Project: Lincoln Public Schools – Irving Middle School Indoor Air Quality Improvements
Irving Middle School
2745 S. 22nd Street, Lincoln, NE 68502

Bid Pckg: #7922

Project No.: Engineers Project No.: 2014-070

ADDENDUM #1

SECOND FLOOR - PHASING PLAN

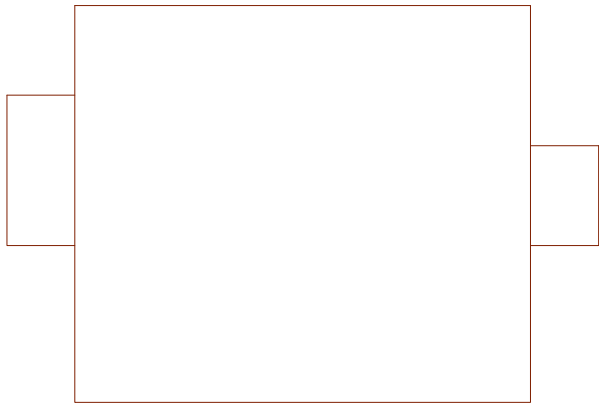
- v. The new Proposal Form is attached at the end of this Addendum.
- C. Section 011000 – Summary
 - i. Replace the Second Floor Phasing Plan drawing with the attached drawing.

Sheet A1.0C

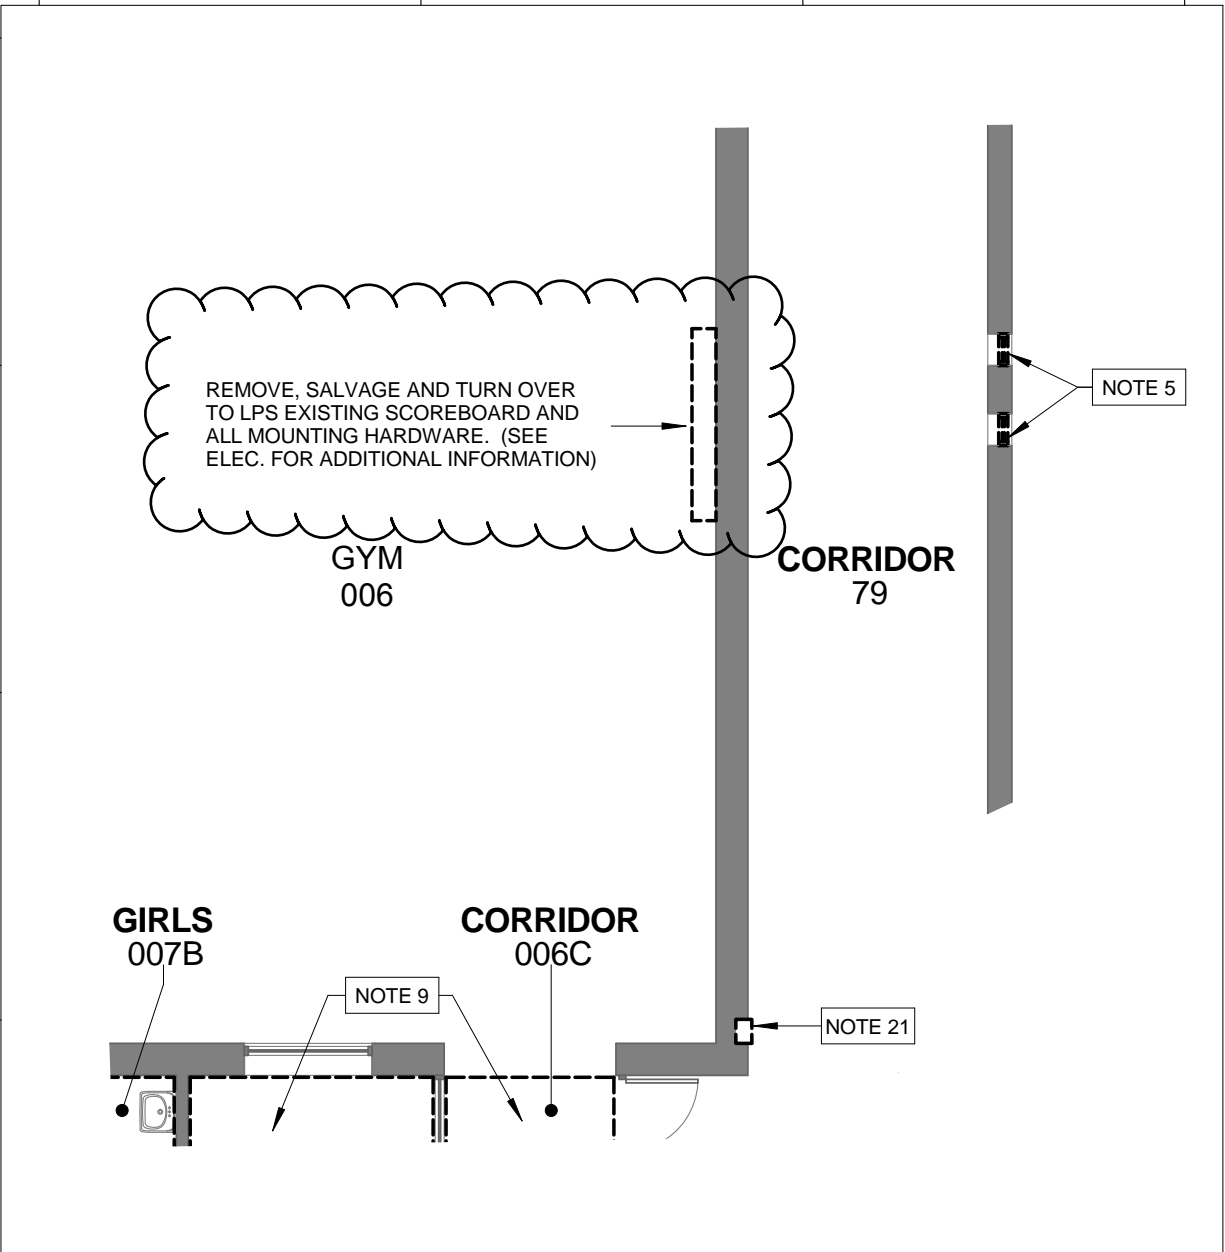
- A. Sheet A1.0C – Demolition Plan – Ground Floor Area C
 - i. Contractor shall remove, salvage and turnover to LPS the existing scoreboard and all mounting hardware located on the north wall of Gym 006 (near the northeast corner – below the roof trusses). See attached sketch A1.0C-1 for clarification. Refer to Electrical for additional information.

Sheet A1.0D

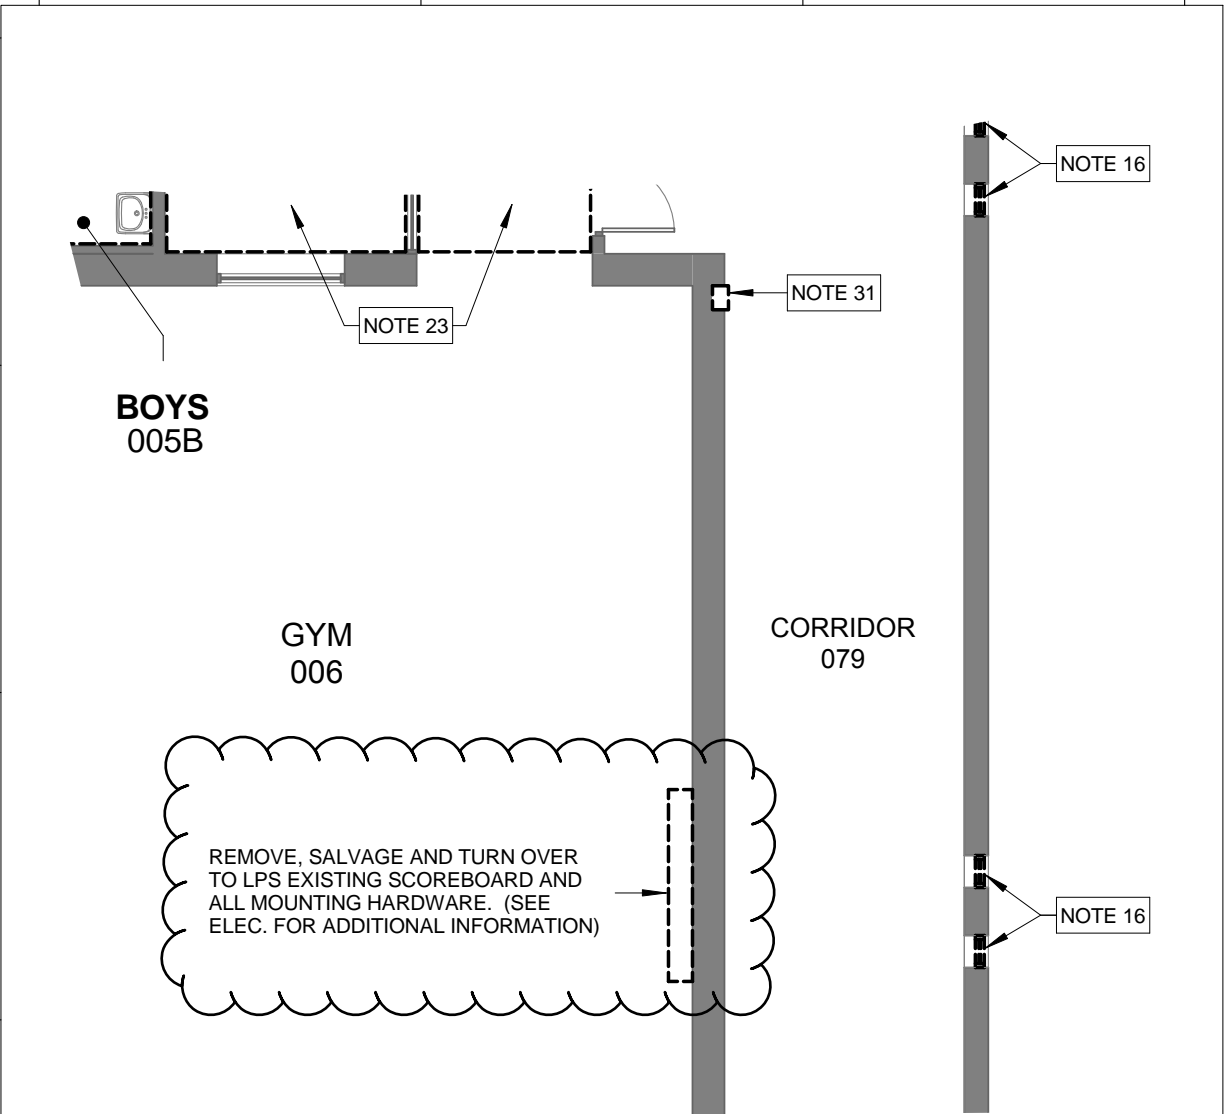
- B. Sheet A1.0D – Demolition Plan – Ground Floor Area D
 - i. Contractor shall remove, salvage and turnover to LPS the existing scoreboard and all mounting hardware located on the north wall of Gym 006 (near the northwest corner – below the roof trusses). See attached sketch A1.0D-1 for clarification. Refer to Electrical for additional information.

Sheet A2.0B

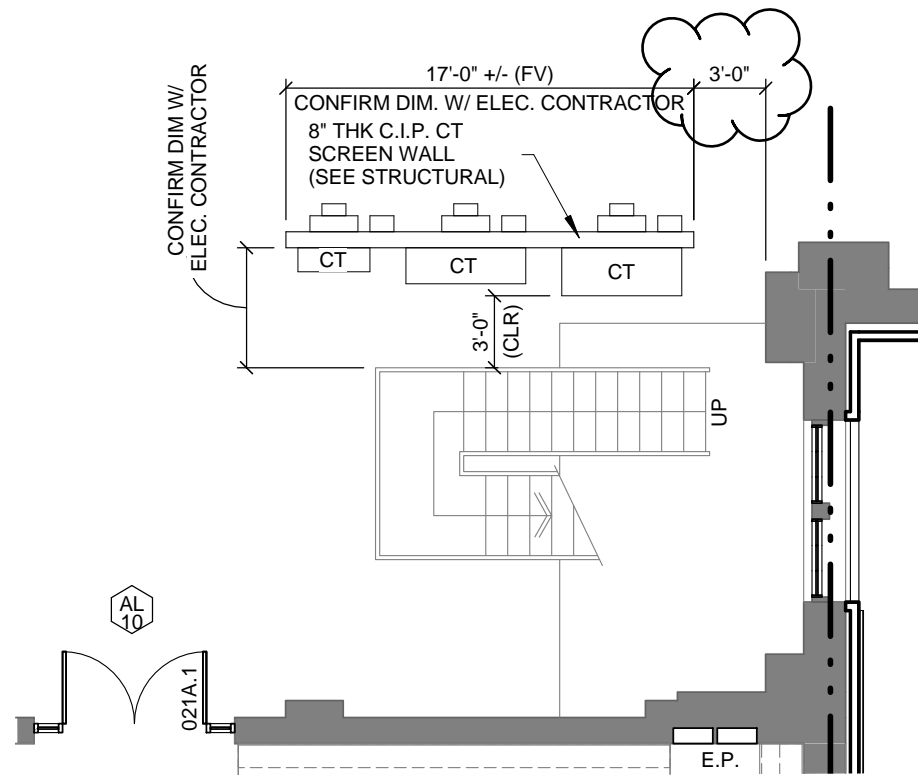
- G. Sheet A2.0B – Floor Plan – Ground Floor Area B
 - i. Locate the north end of the CT screen wall (located north of the LES transformers on the west side of the building) 3'-0" south of the adjacent (existing) masonry pilaster. See attached sketch A2.0B-1 for clarification.

Partial Floor Plan - First Floor Area B
 Sheet A2.1B

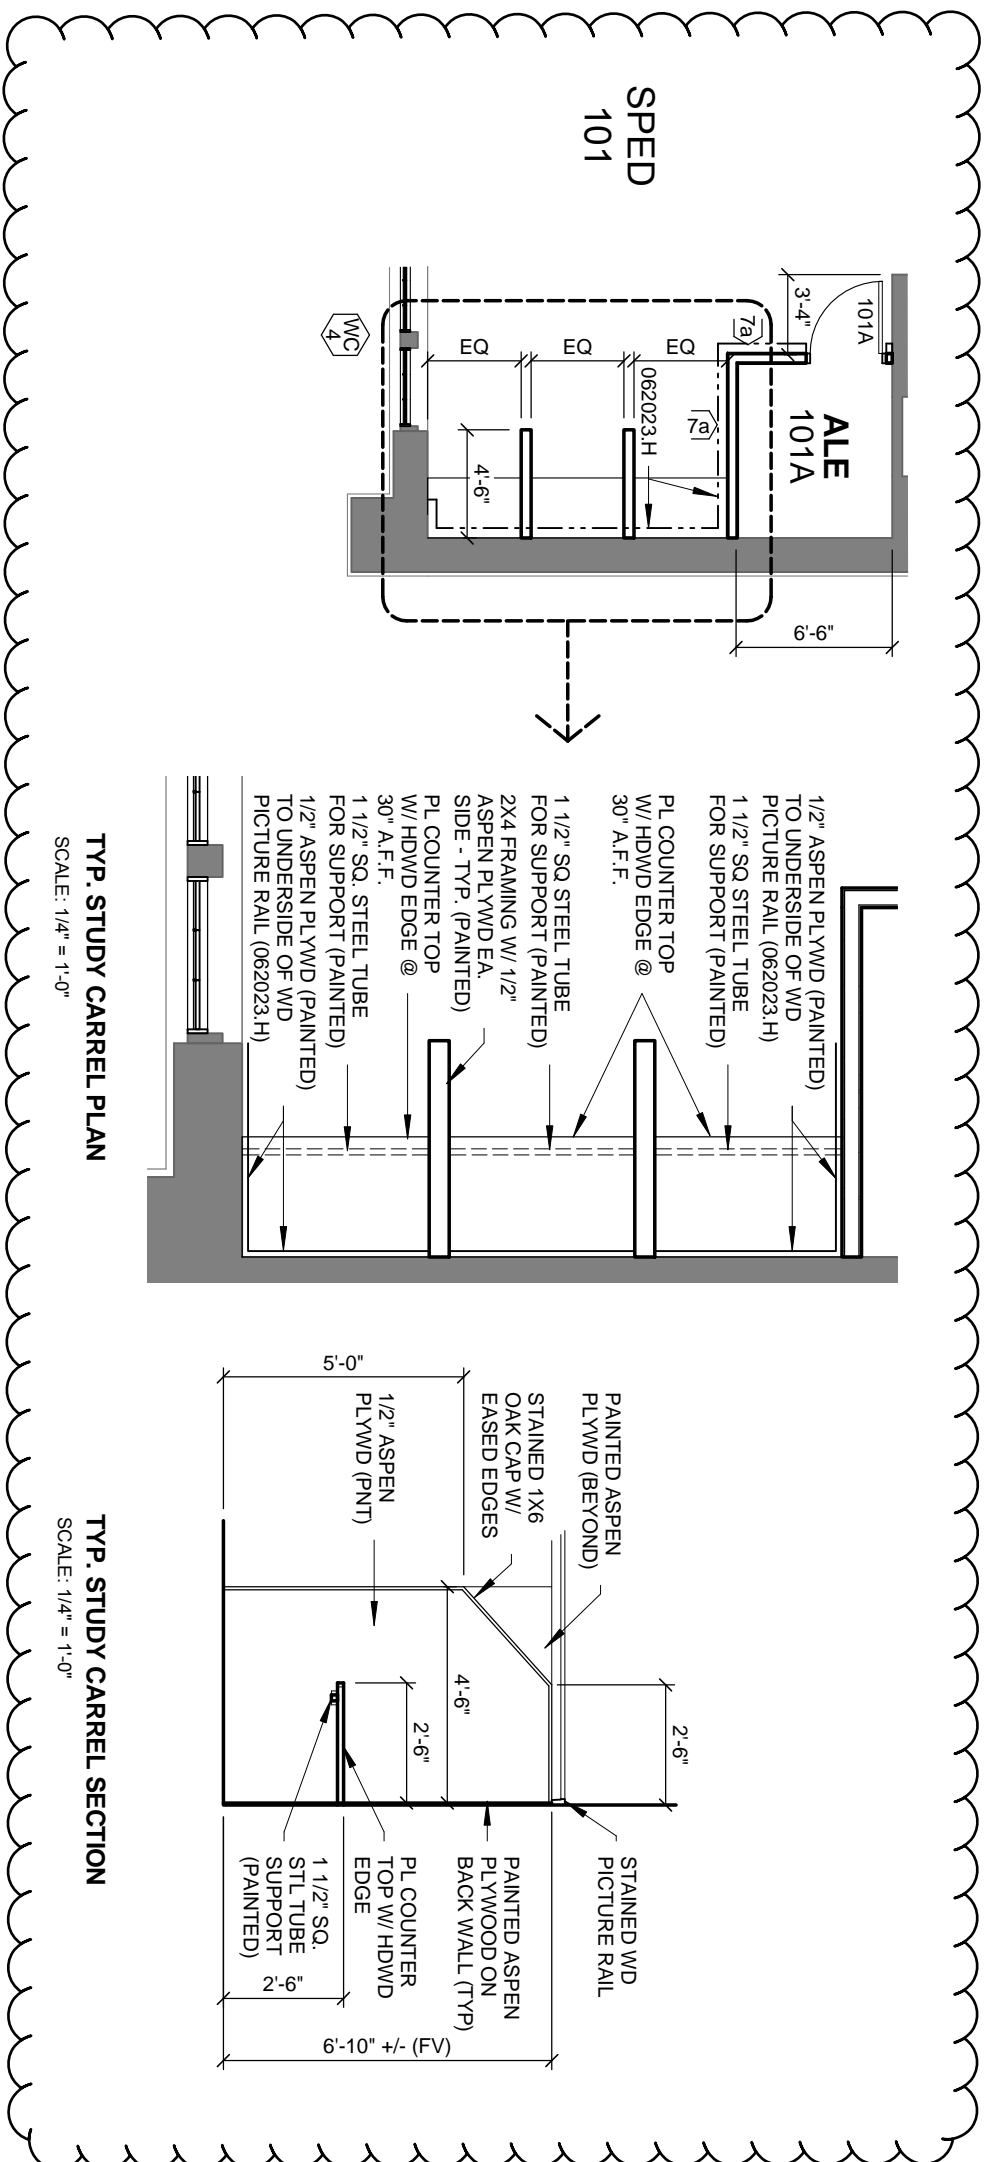
- I. Sheet A2.1B – Floor Plan – First Floor Area B
 - i. Construct three (3) study carrels adjacent the northeast corner of SPED 101. See attached sketch A2.1B-1 for clarification.

Sheet A3.2

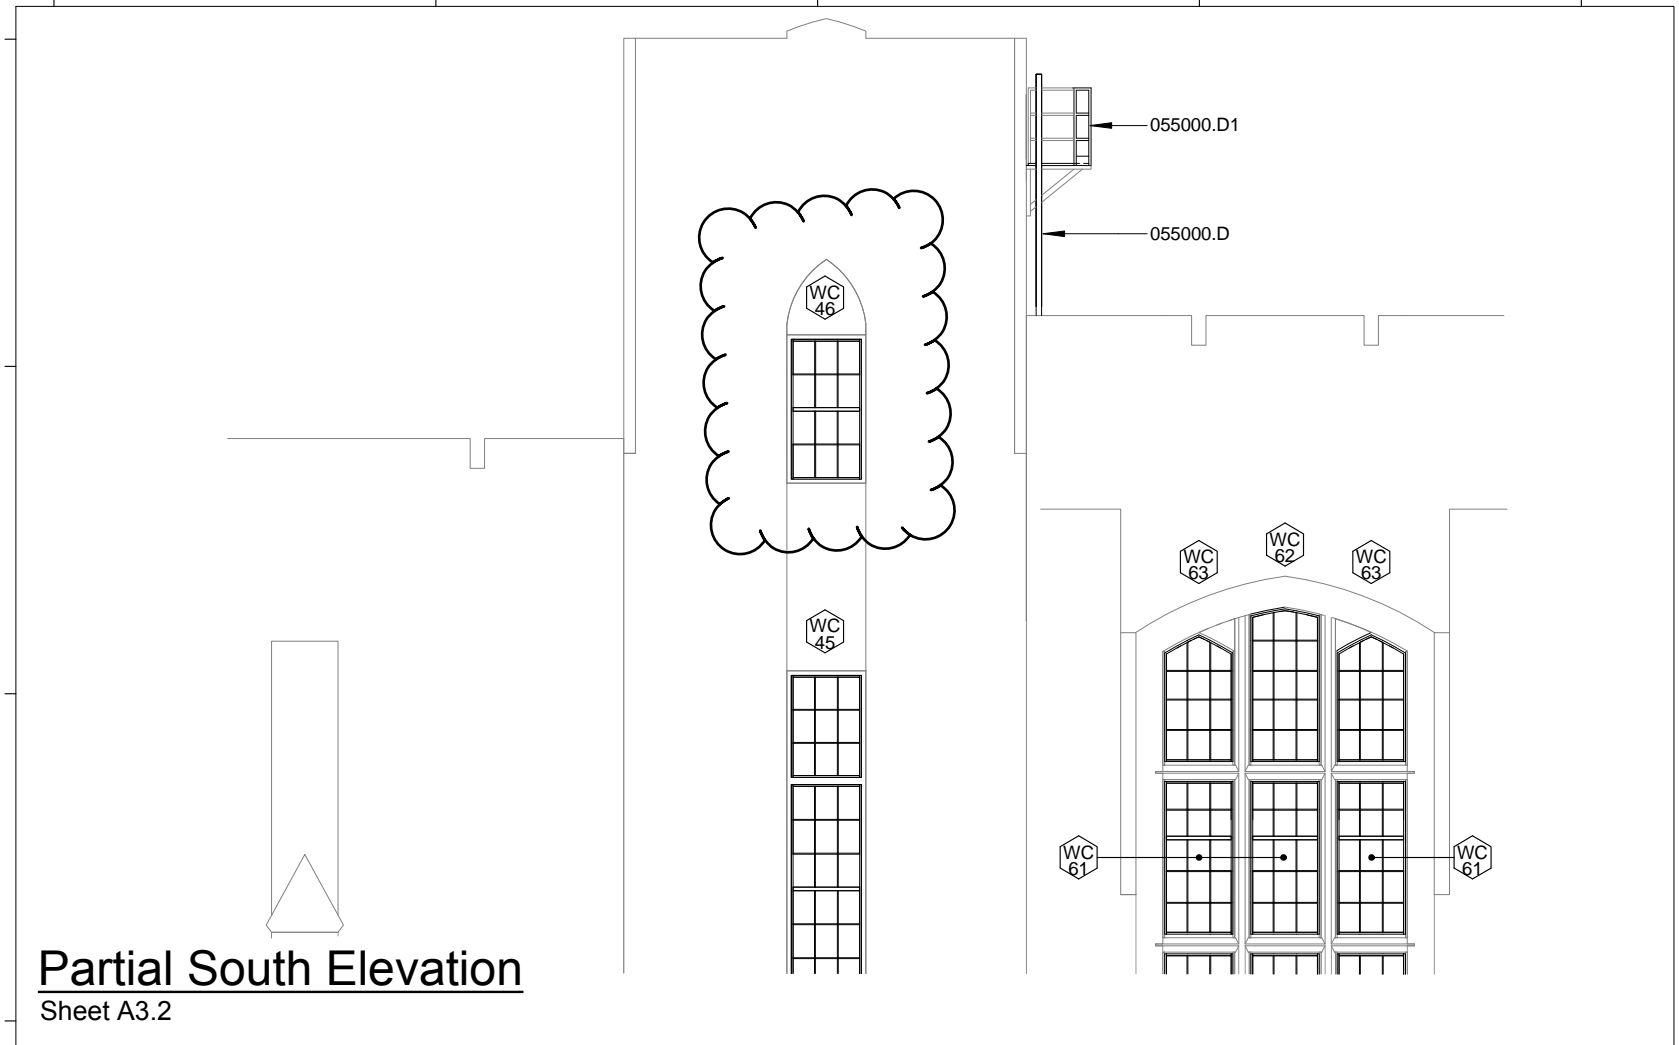
- J. Sheet A2.4B – Floor Plan – Fourth Floor Area B
 - i. At the north side of Music 400 and 401 there are three (3) existing openings that are to receive metal panels. The notes indicate the width of the openings but not the height. These openings are approximately 8'-0" tall.
- K. Sheet A3.2 – Elevations – North and South Original Building
 - i. Refer to M1 South Elevation – Towards the west end at the top of the fly loft wall, there is a window notation WC 46, but no window shown. There is a window Type WC 46 in the blank rectangle below the notation. See attached sketch A3.2-1 for clarification

SHEET
E1.1B

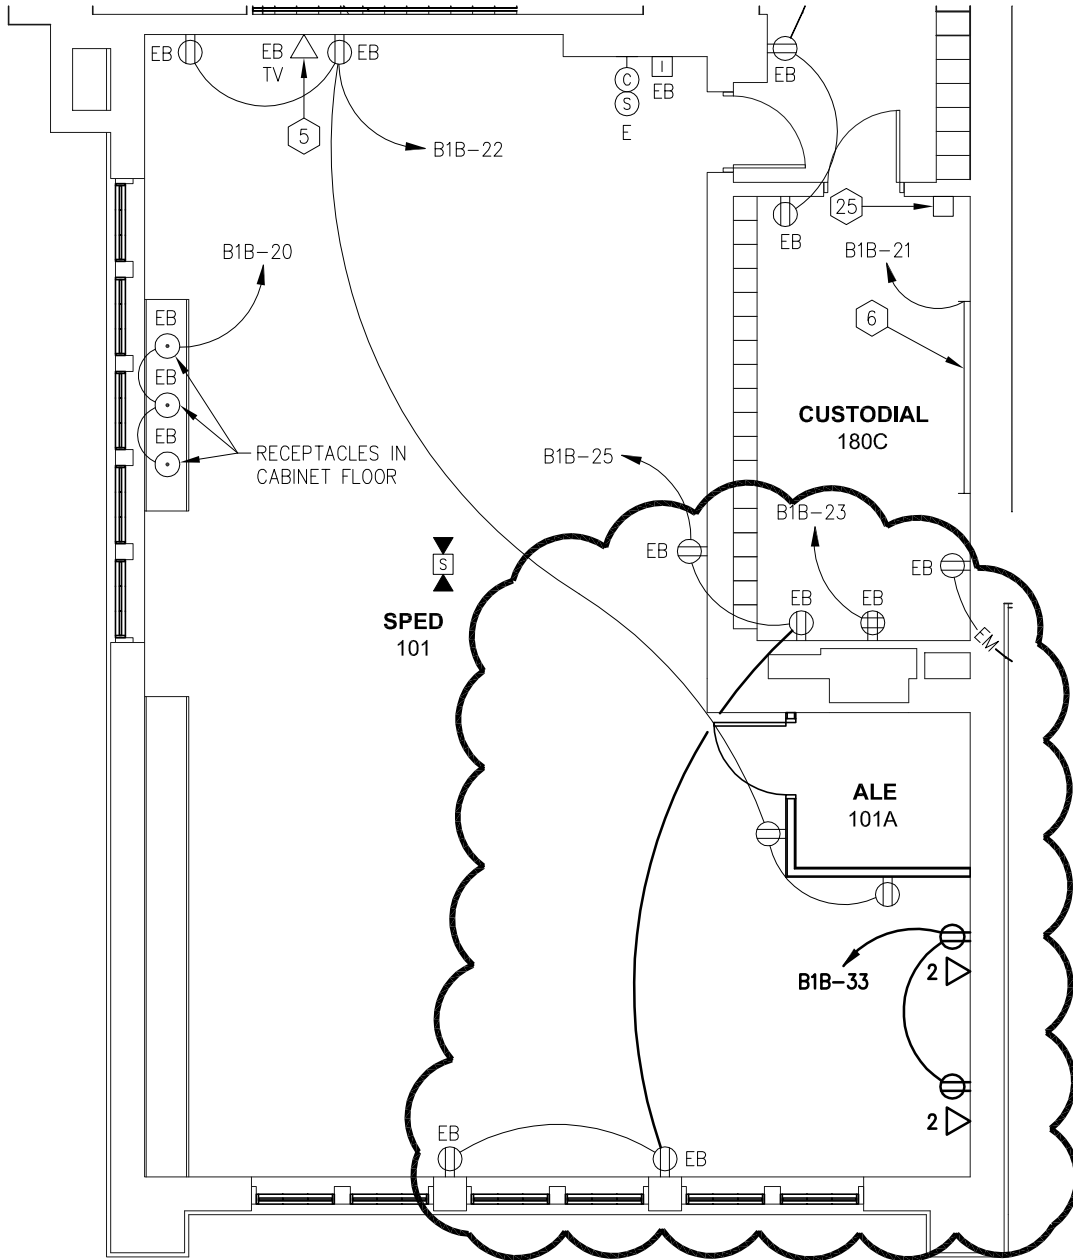
- B. Sheet E1.1B First Floor Plan – Area B – Electrical Demolition
 - i. Change Note 22 to read the following – “REMOVE AND SALVAGE EXISTING DATA RACK AND TURN OVER TO THE OWNER.”

SHEET
E3.1B

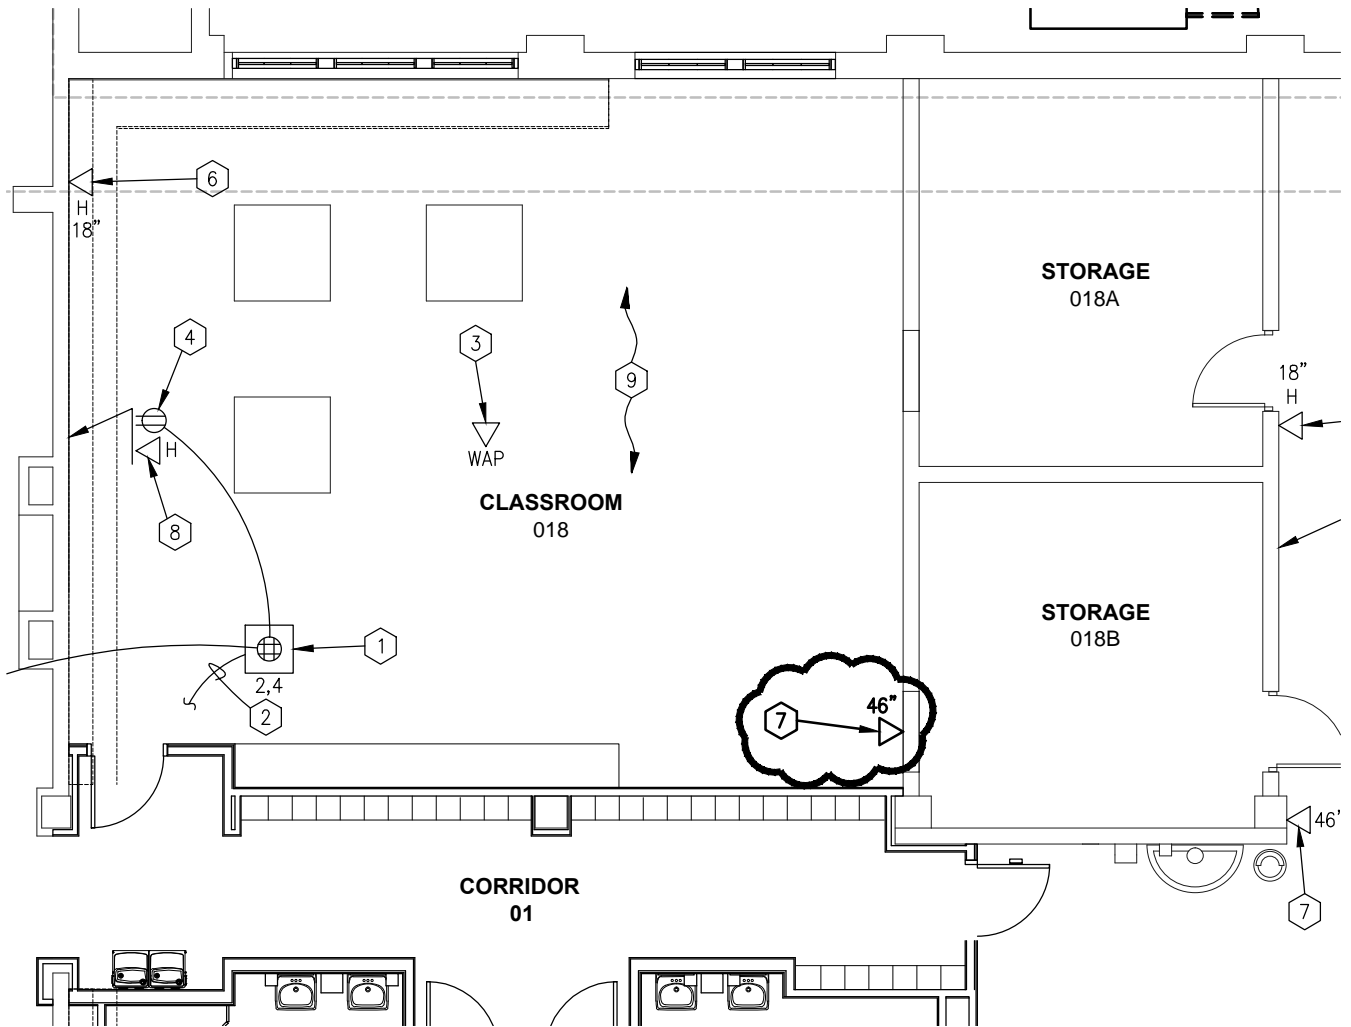
- F. Sheet E3.1B – First Floor Plan – Area B – Electrical
 - i. See attached drawing for new data and power in Sped. 101.
